Change Order, Construction Manager as Adviser Edition

Christian County High School
5185 Fort Campbell Blvd
Hopkinsville, KY 42240

Change Order Number: 091
Date: November 05, 2025

Cost associated with deleting Area F projector per PR #43. Main gym scoreboard electrical revisions per PR #61. Gym stair 2 nightlight per PR #63. Add receptacle and data-Area K per PR #64.

Pekin High School
Pekin, IL 4-Face
3.9mm Video Display
Electrical Installation

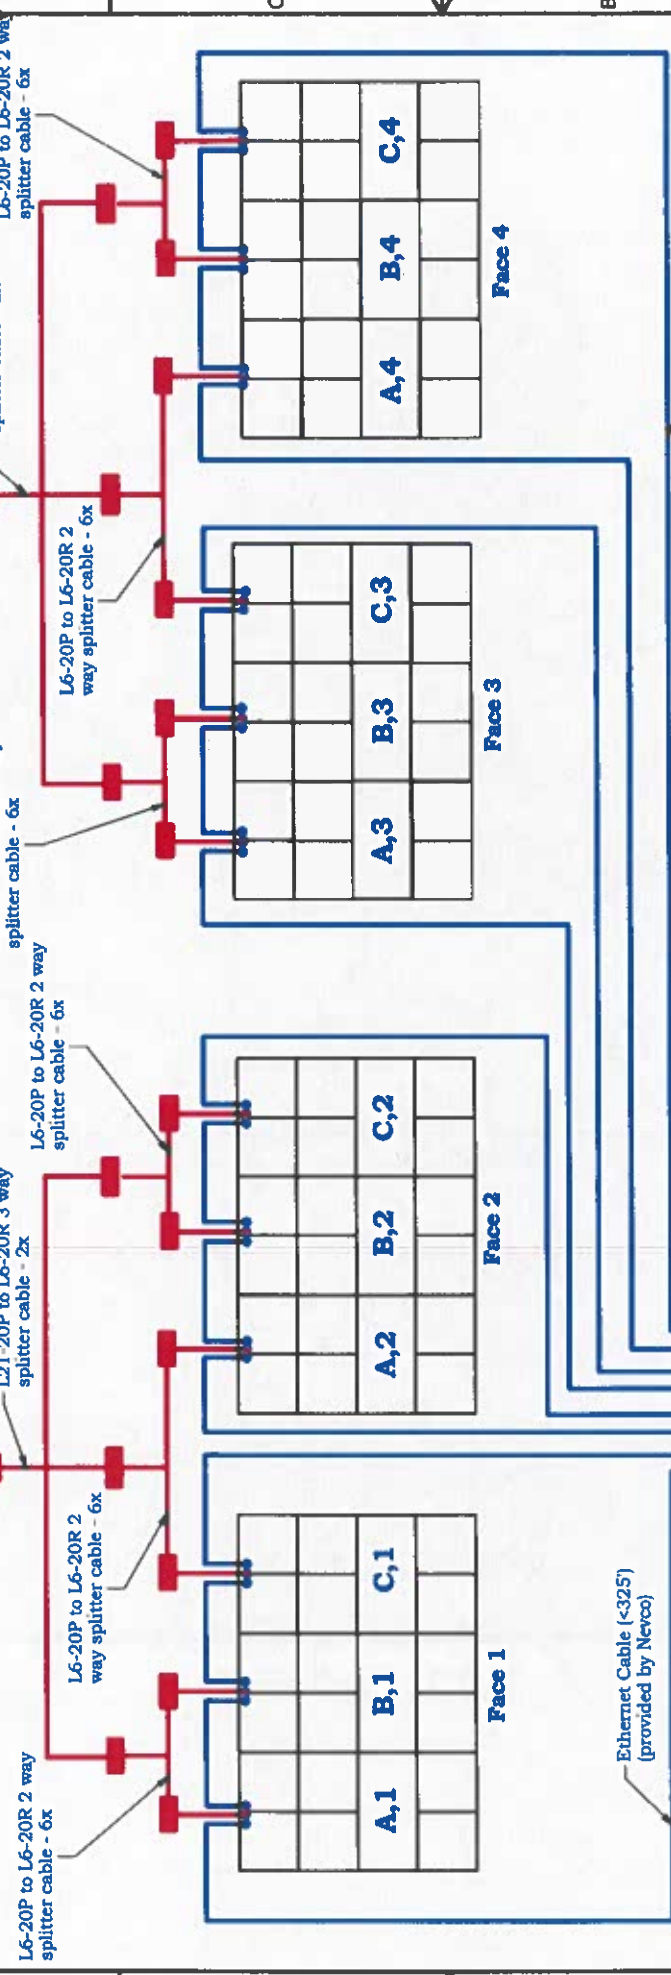
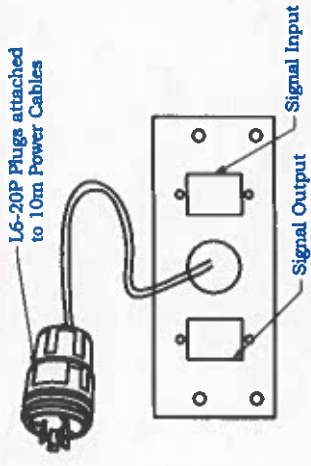
- 4) In lieu of the quantity one 20A, 120V single-phase circuit to the score board, provide a quantity of two 20A, 208Y/120V circuits to the video score board. Terminate the two circuits each within a L21-20R receptacle at the video score board per equipment provider's requirements.
- 5) The "C2" data outlet as shown on the original Contract Drawing E3.2B-Alt shall remain and be installed within the new video scoreboard for an owner-furnished and installed wireless access device.
- 6) Provide two 1" conduit raceways from the video scoreboard to the Area B data room B191. The video scoreboard provider will furnish and install eight ethernet cables (four within each

conduit) from a scoreboard video controller within data room B191. (See attached sample electrical installation for Pekin High School) for additional information regarding the NEVCO video scoreboard system.

Requires (2) Branch Circuits
Use high inrush current circuit breakers for video displays.

8x Ethernet Cable (<325')
(provided by Nevco)

Project No.	21-08-204
Project Name	Lighting Plan - Second Floor - Area B
Client	Christian County Public Schools
Architect	David M. Smith
Engineer	David M. Smith
Scale	1/8" = 1'-0"
Sheet No.	E4.2B-AIT

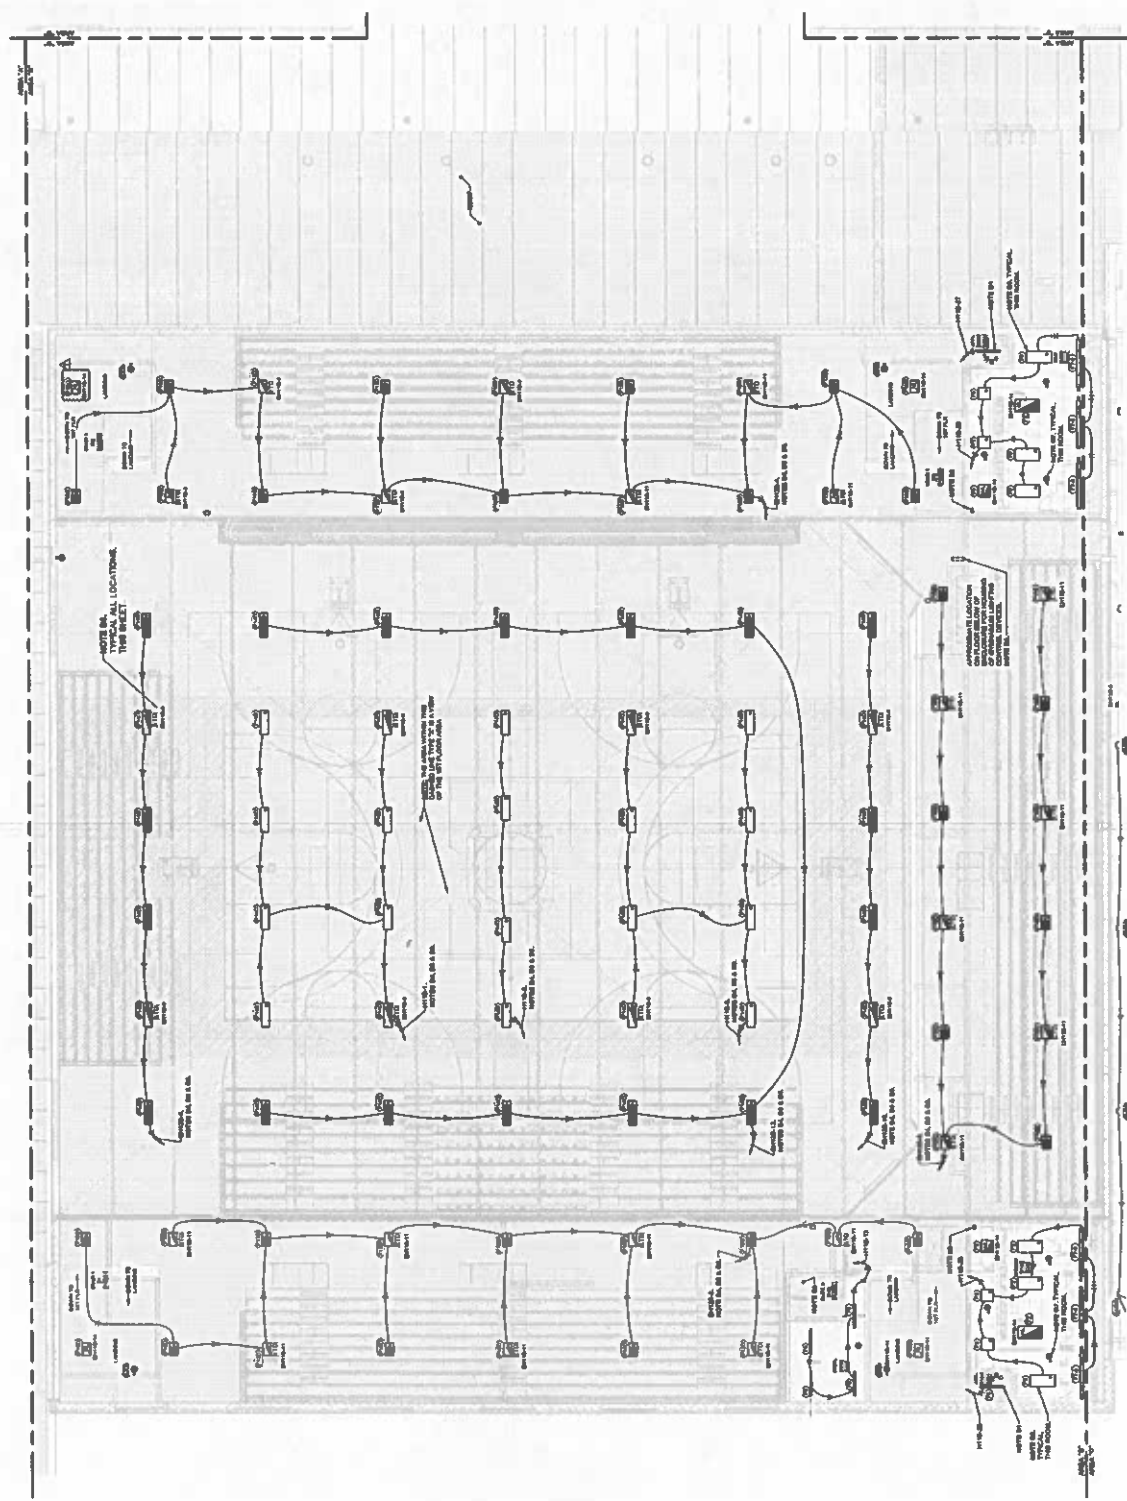
- 1) Reference revised drawing E4.2B-Alt Rev 1:
 - a. Added "F13D" type lighting fixture above Stair 2 as night light.
